PROJECT NAME:
Brighton Area Schools – BHS Rooftop Unit Replacement & Renovations

COMM. NO. 26022

ADDENDUM NO. 02

DATE: July 22, 2026

POTENTIAL STAGING AND
FENCED STORAGE AREAS -
TYP.

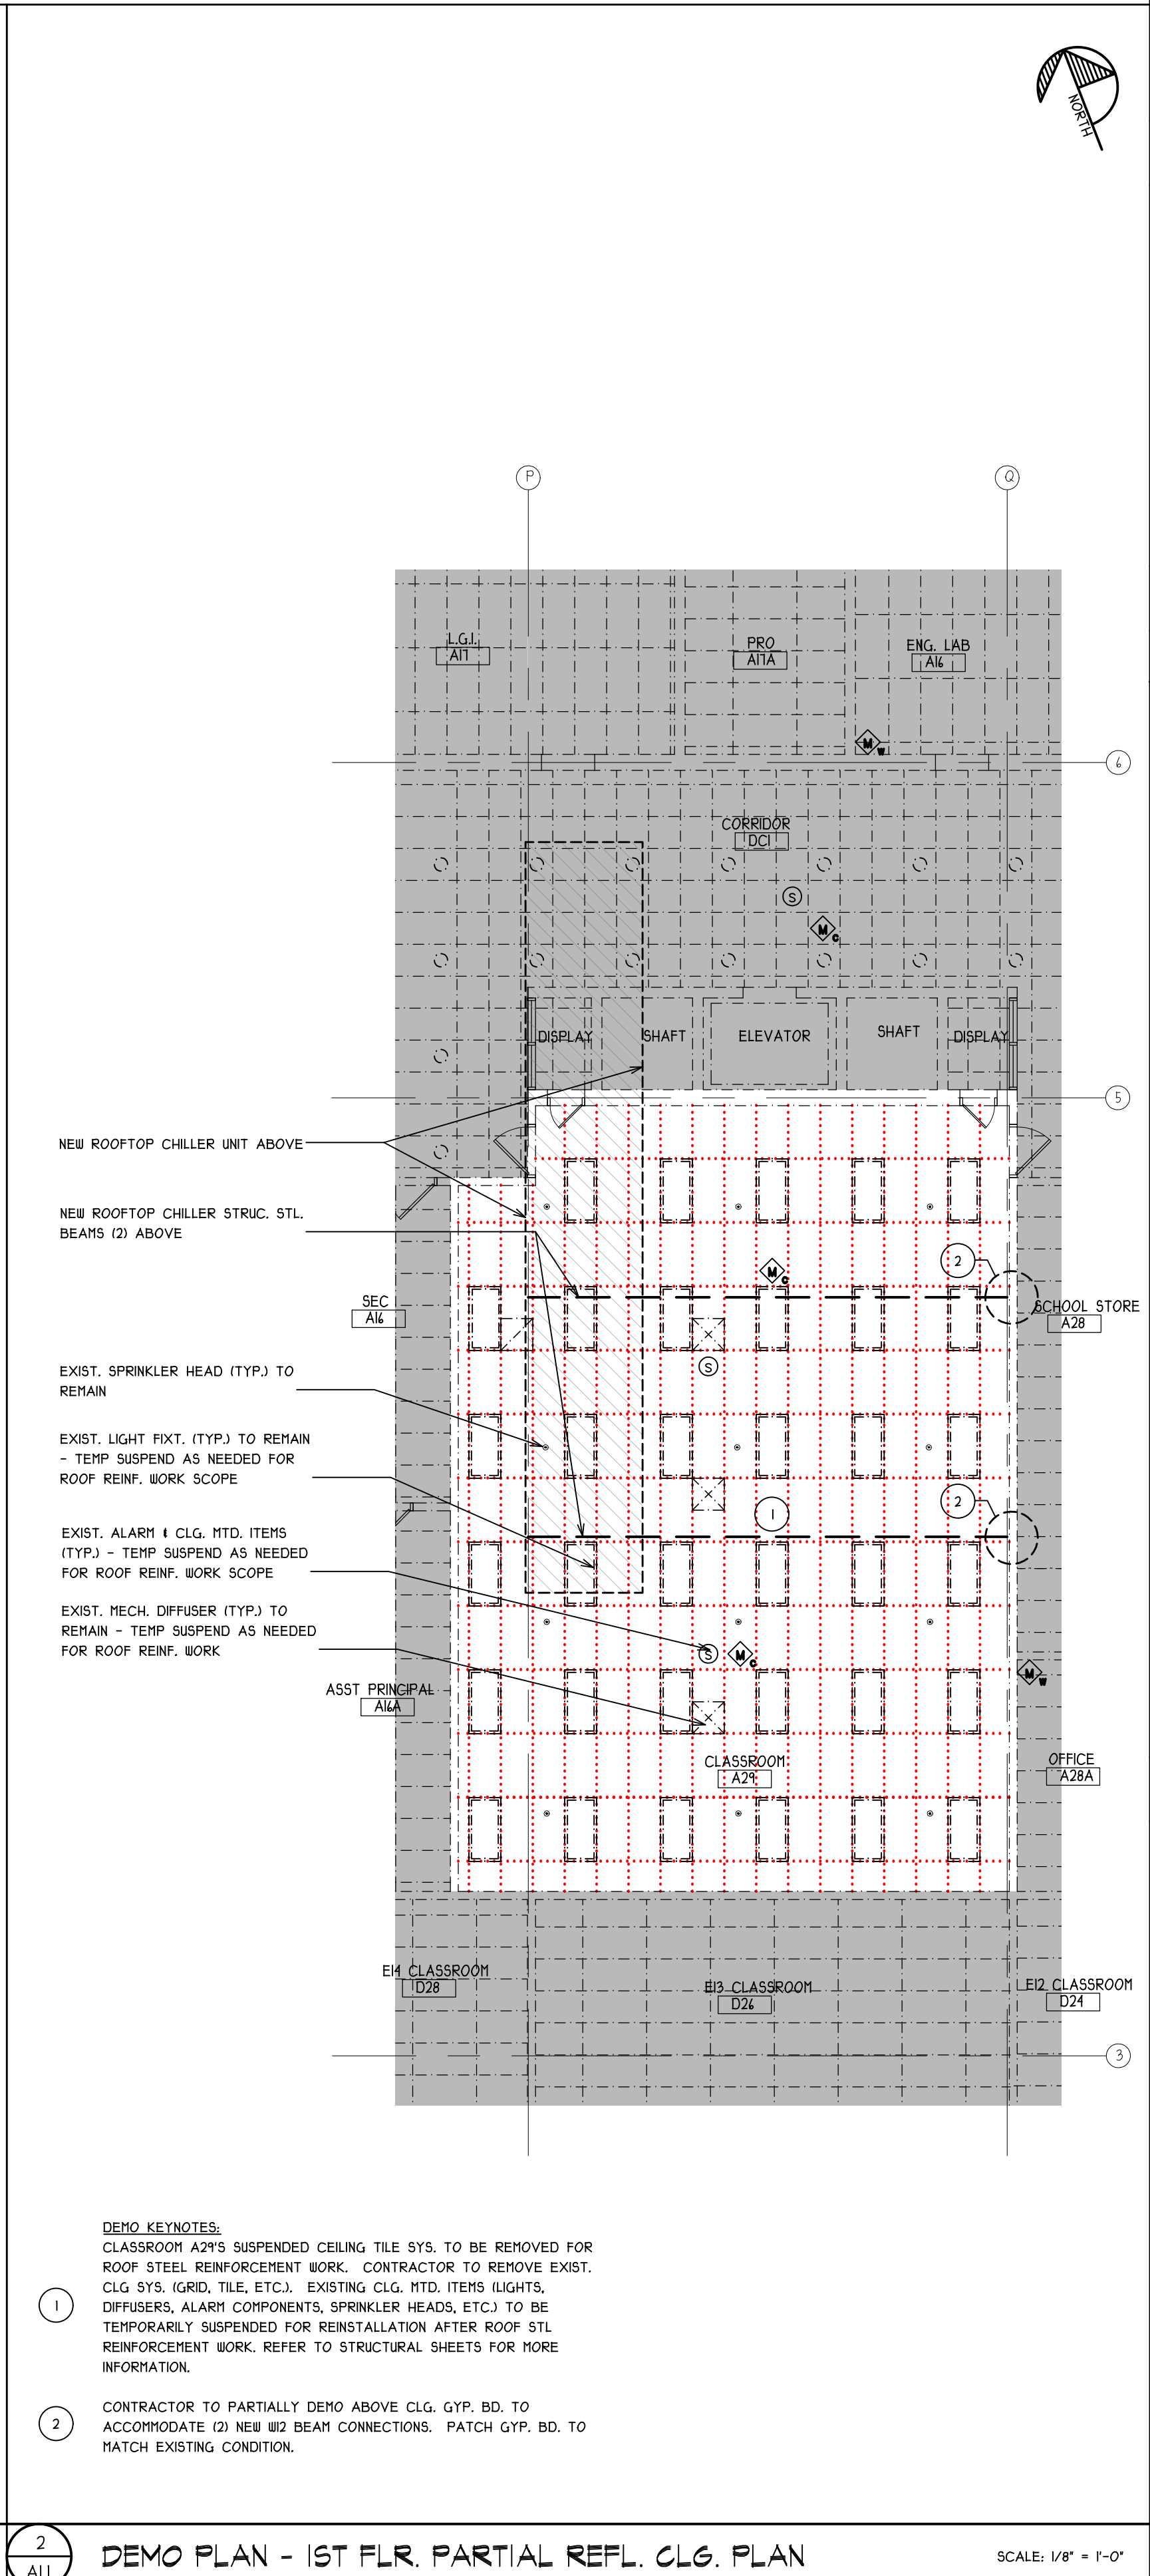
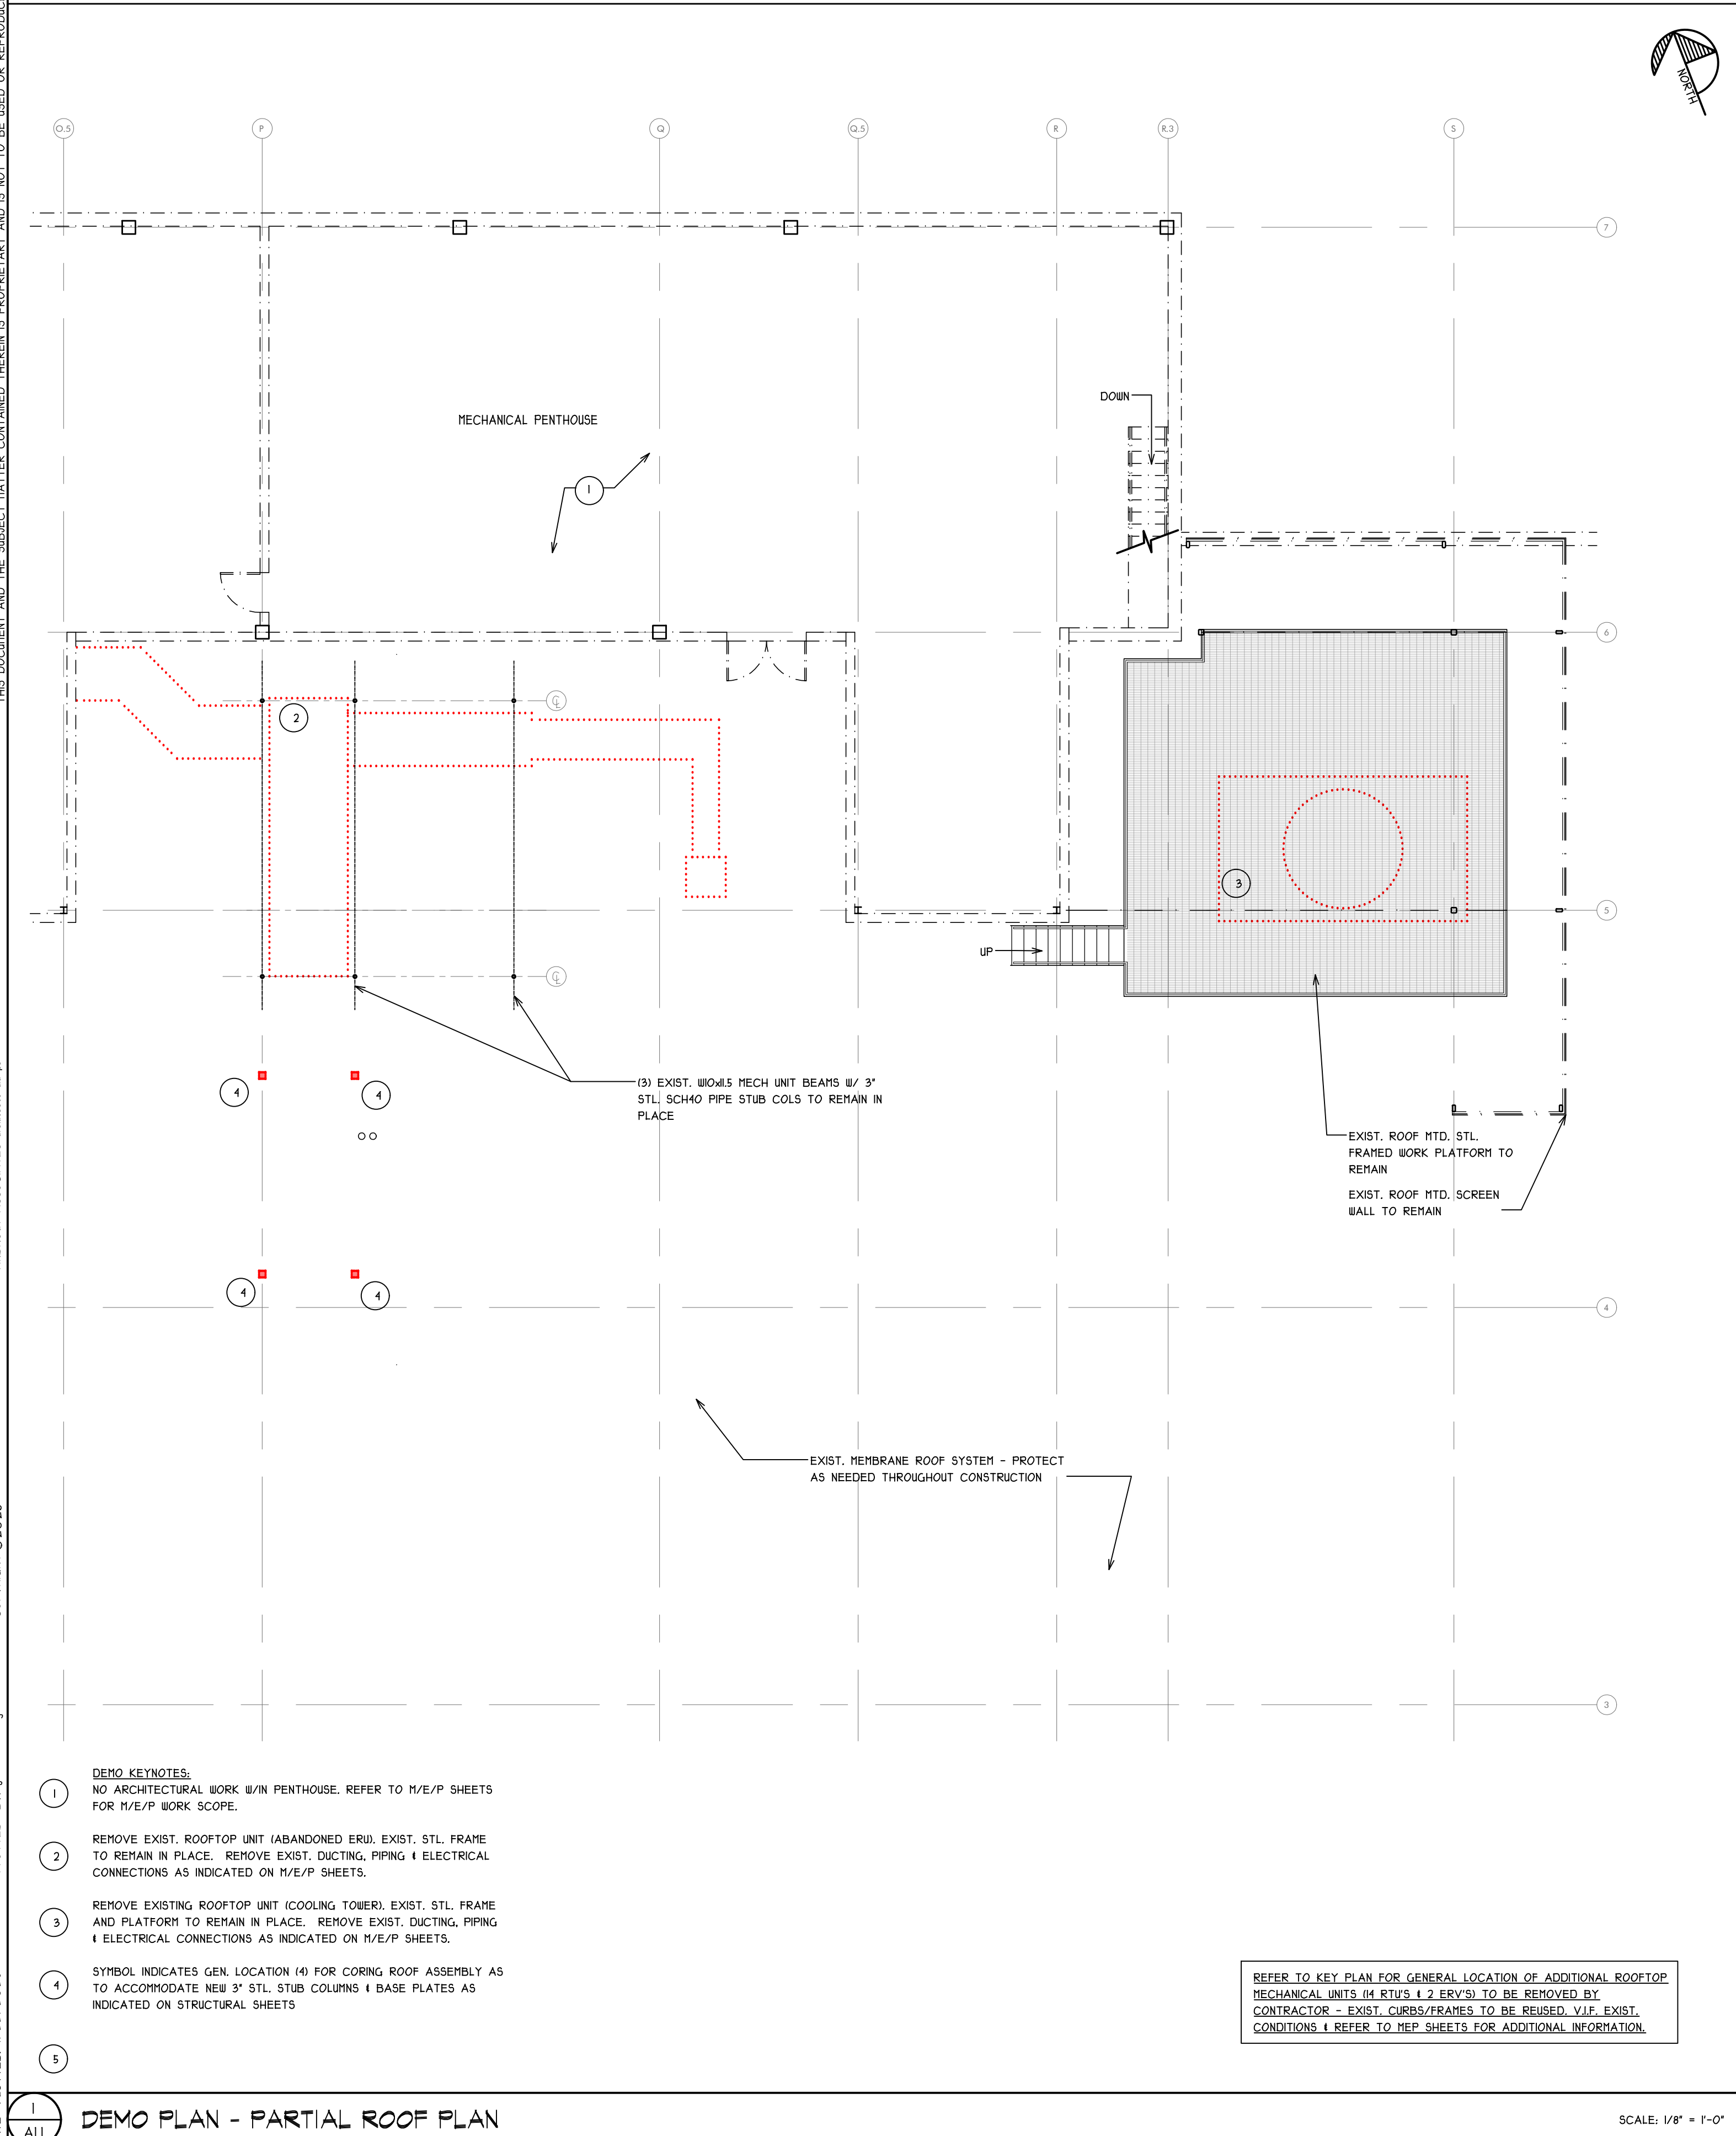
- 09 CLARIFY - Contractors should assume minimal scope of roofing (inspection, caulking and sealing as needed for a watertight fit) at RTU's.
- 10 ADD - Contractor to assume 1,000 feet of temporary 6' tall chain link fencing and swing gates as necessary. Contractor to provide cost per lineal feet of the fencing. Refer to the attached site diagram for additional information.
- 11 CLARIFY – refer to the attached site diagram for additional information (heights, assumed staging areas, etc.) and planning purposes.

PIPE SUPPORT DETAIL

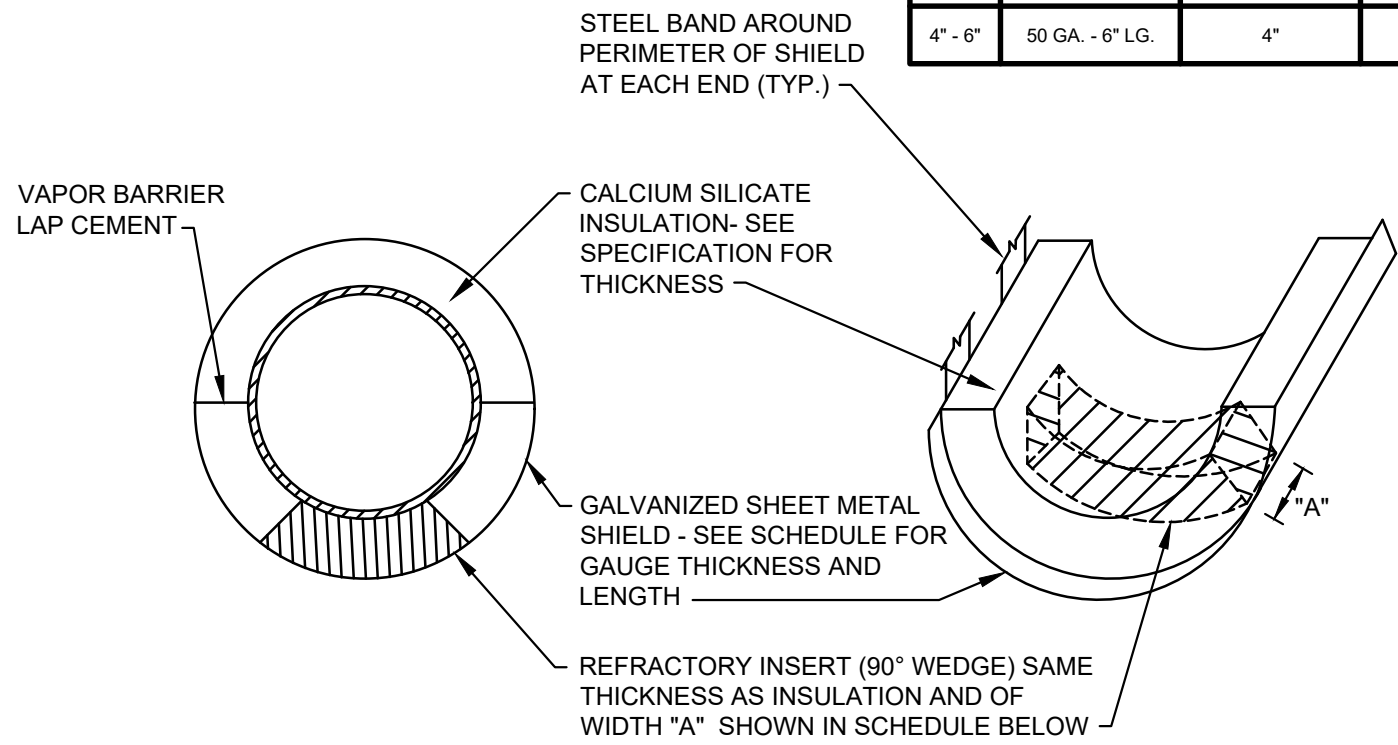
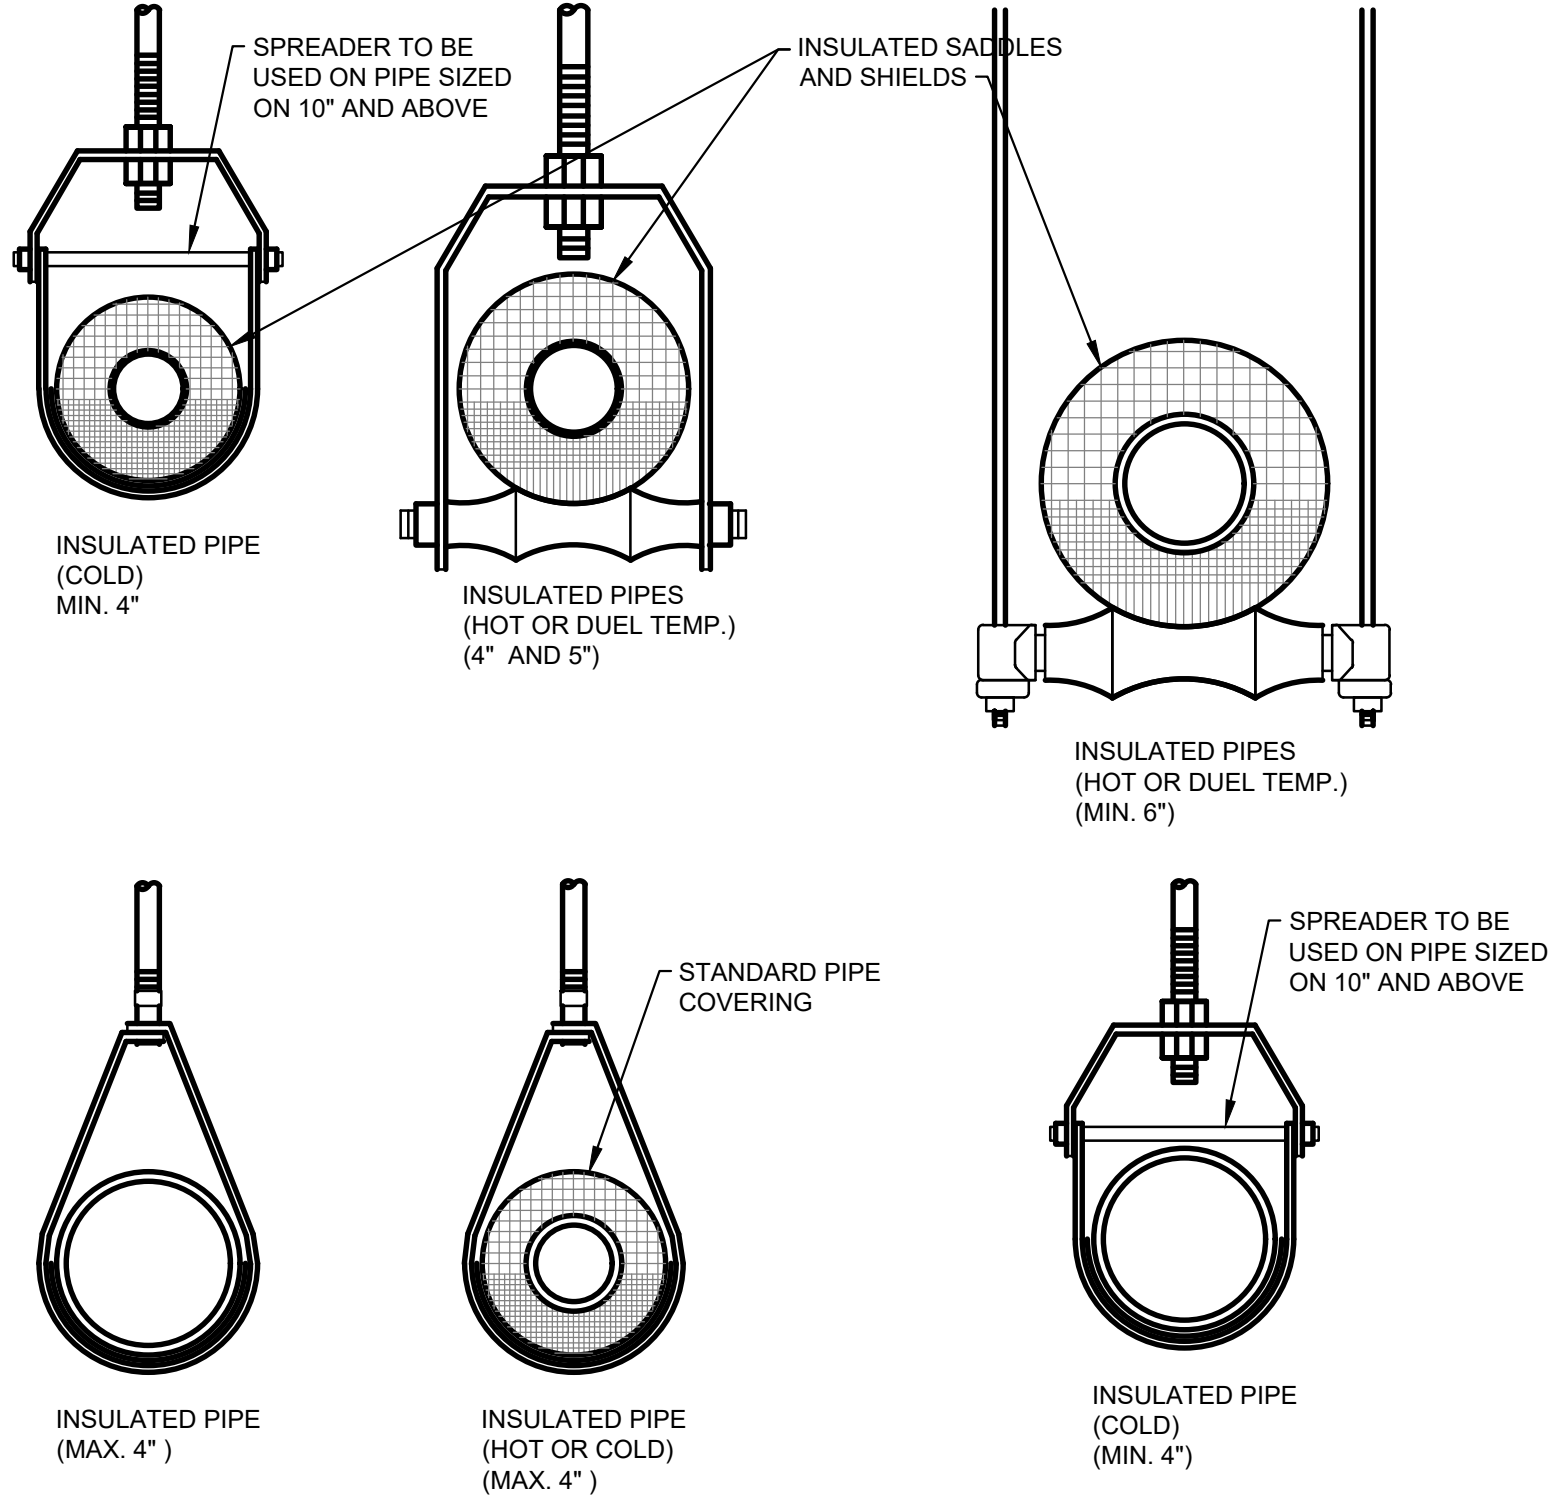
| 03 | CLARIFY - Refer to updated drawing sheets M2.0 and M1.3 for additional information regarding rooftop pipe supports. |
